NRC COMMENTS
ON
DOE DRAFT ENVIRONMENTAL ASSESSMENT
FOR THE
LAVENDER CANYON SITE

March 20, 1985

Section 3.3.2.1, Hydrology and Modeling, Page 3-132 to Page 3-134, Table 3-12

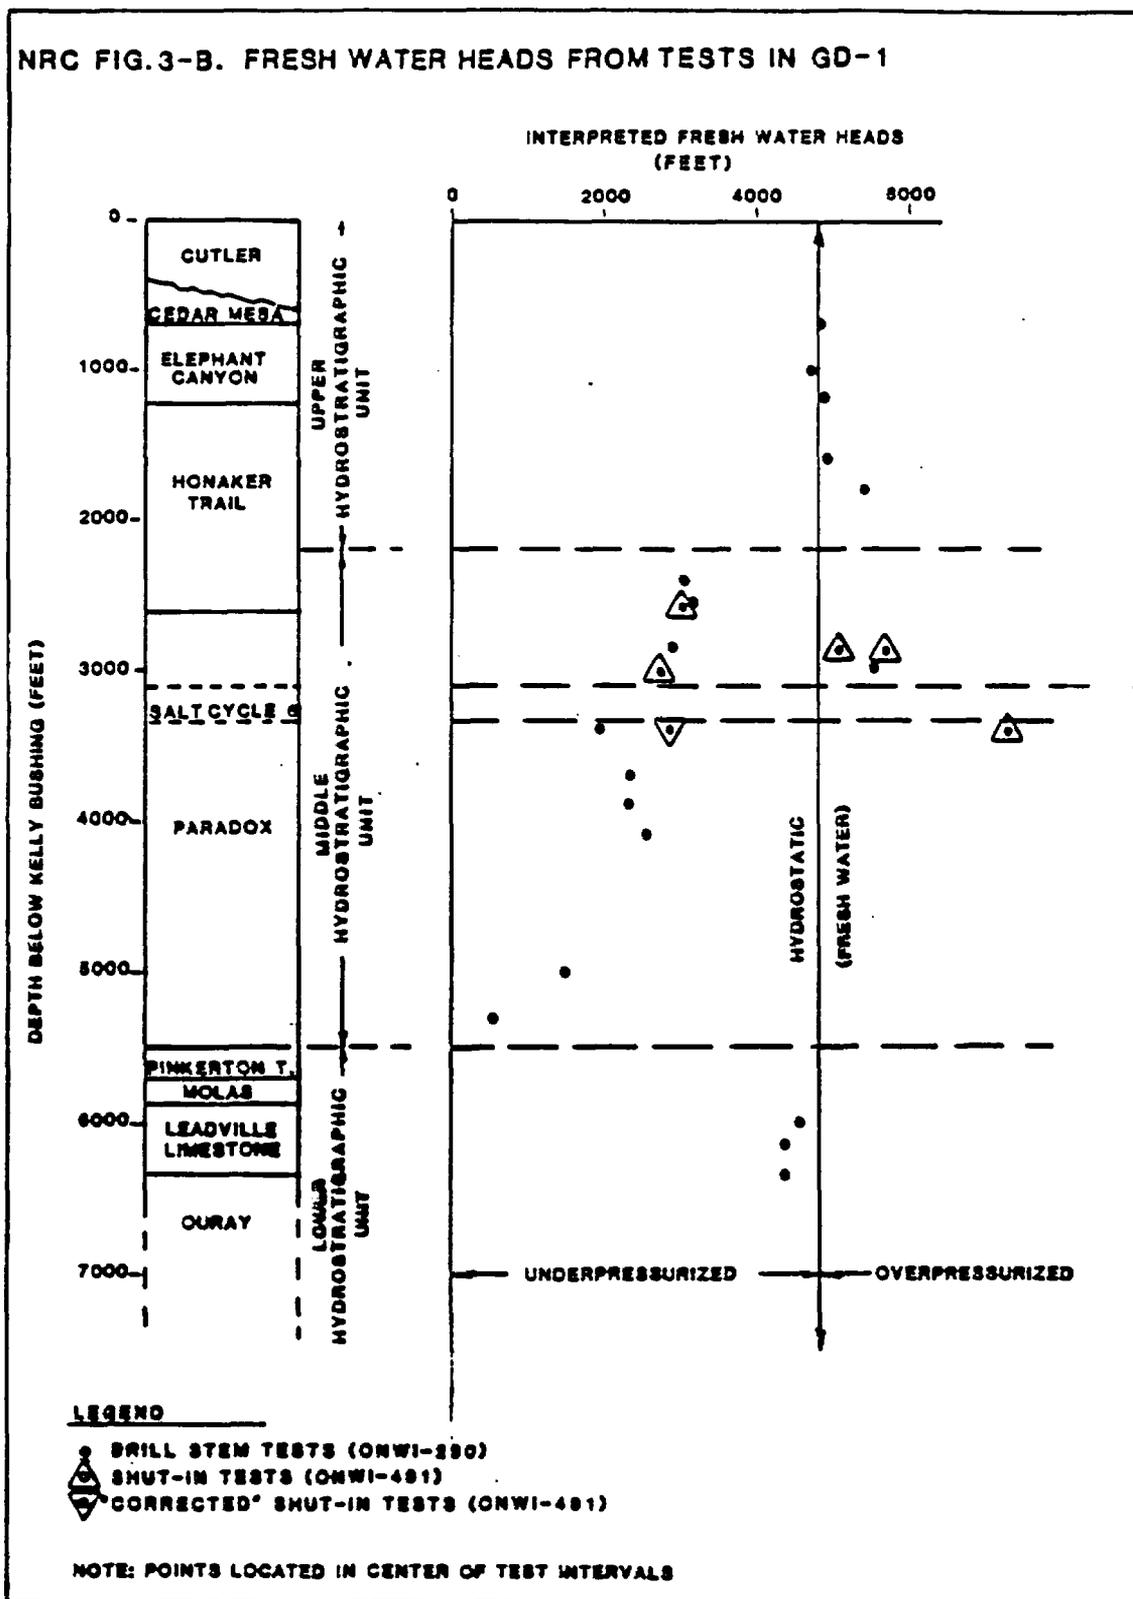
This Table does not show all potentiometric head data collected by the DOE at borehole GD-1 which are used to support conclusions in the draft EA. If the potentiometric and estimated static reservoir data collected in the second series of tests (August-September, 1982) at borehole GD-1 were added to this table, complete consideration of the range of possible interpretations of gradient and flow direction for the middle hydrostratigraphic unit would be facilitated.

Head data from borehole GD-1 are variable. Figure 3-B (below) depicts the short-term drill stem test head data (data points shown as circles) presented on Table 3-12 of the draft EA which were collected at borehole GD-1 from March 1980 to January 1981. The Figure also shows and the long-term shut-in test data (shown as triangles) collected at borehole GD-1 during August-September 1982 (Thackston, et al., 1984, Table 4-2). The Figure shows that the potentiometric head profile within each the upper and lower hydrostratigraphic units conforms to a hydrostatic profile (0.4333 psi/ft Thackston et al., 1984, p.11). In contrast, head within the Paradox Formation varies considerably with depth. The NRC concludes that consideration of the long-term test data increases the variability of measurements significantly. The long-term test data can be interpreted to indicate several alternative hydraulic conditions at borehole GD-1, including overpressurized and underpressurized conditions, and the possibility of localized upward and downward gradients. If there is localized vertical interconnection in these units, these head data suggest that there may be localized downward and upward flow. Hydrochemical data from borehole GD-1 may further substantiate the potential for localized upward gradients between the middle and upper hydrostratigraphic units (see detailed comment 3-30).

NRC FIGURE 3-A AFTER DOE FIGURE 3-40

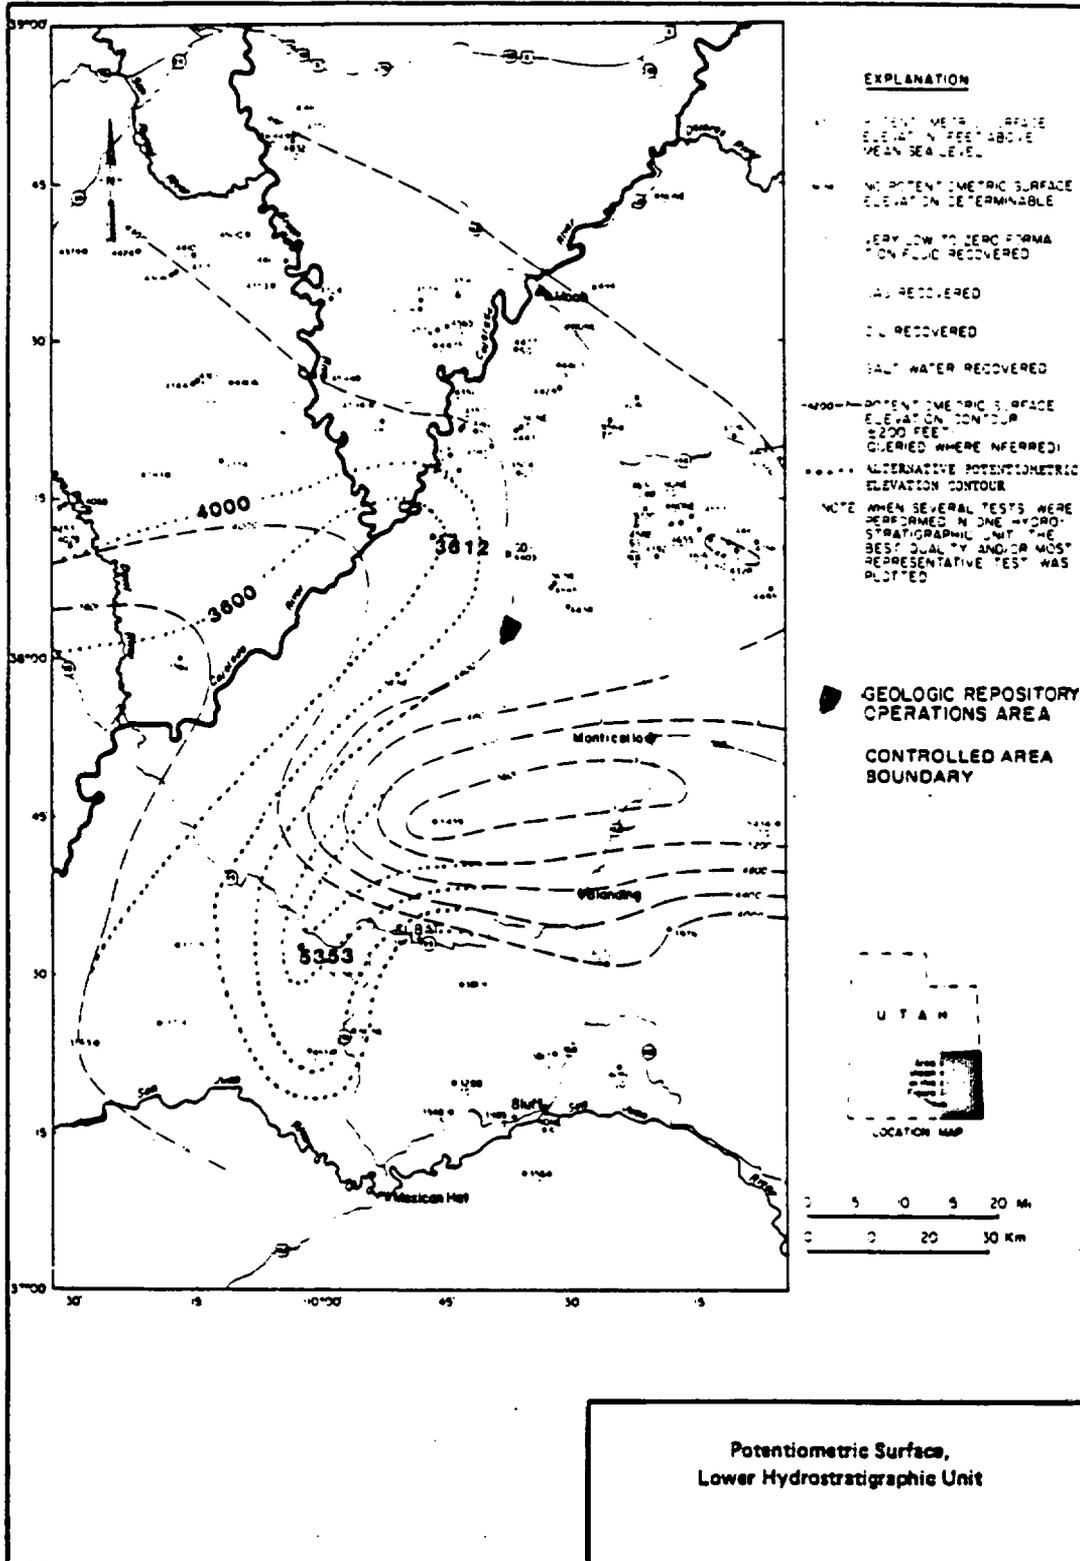
The DOE presents a map (Figure 3-40) of the potentiometric surface of the lower hydrostratigraphic unit which includes incorrect values and inconsistencies when compared with the referenced data source (Woodward-Clyde, 1982, Vol. V, Appendix A). A revised potentiometric map based upon consideration of the concerns discussed below would alter flow direction to a northwest direction.

The Figure 3-40 map may include an incorrect head value. A well located immediately west of borehole GD-1 is labeled with a head value of 4,195 feet on Figure 3-40, but is listed at 3,612 feet in Appendix A (Woodward-Clyde, 1982, Vol. V). A change of the plotted value to 3,612 feet alters the shape of the potentiometric surface significantly by creating a major reentrant for the 4,000 to 3,600 foot contour lines. Given a revised potentiometric map based on this change, the flow path direction under the Davis Canyon site changes to a strong northwest trend; flow goes more directly toward the Colorado River.

There are additional discrepancies between Figure 3-40 and Appendix A. Second, some wells plotted in Figure 3-40 are not listed at all in Appendix A. For example, a well located near the northwest corner of the map area, with a head value of 4,379 feet, is not listed in the appendix. Conversely, some wells

listed in the appendix are not plotted on Figure 3-40 or its earlier versions. For example, a well listed in Section 27 of T.37 S., R.17 E., apparently has not been plotted in the figure. If this well is plotted and the correct value is plotted for the well near borehole GD-1, the shape of the potentiometric surface is altered significantly. In addition, many of the wells listed in Appendix A (Woodward-Clyde, 1982), have head values obtained from testing more than one interval. A note on Figure 3-40 indicates that a selection process was used to determine which one of the values was to be plotted; however, no discussion is presented in Woodward-Clyde, 1982, or the draft EA to explain the basis of the selection process. Selection of values other than those used could also significantly alter the potentiometric surface map.

Replotting of Figure 3-40 after the alterations described above can produce an alternative potentiometric surface for the Leadville Formation. The configuration of the alternative potentiometric surface map is presented below (see Figure 3-A). This alternative potentiometric map indicates that the Colorado River may be a much stronger hydraulic sink northwest of the geologic repository operations area than was the case for the original map. The gradient between the repository and the river is steepened.
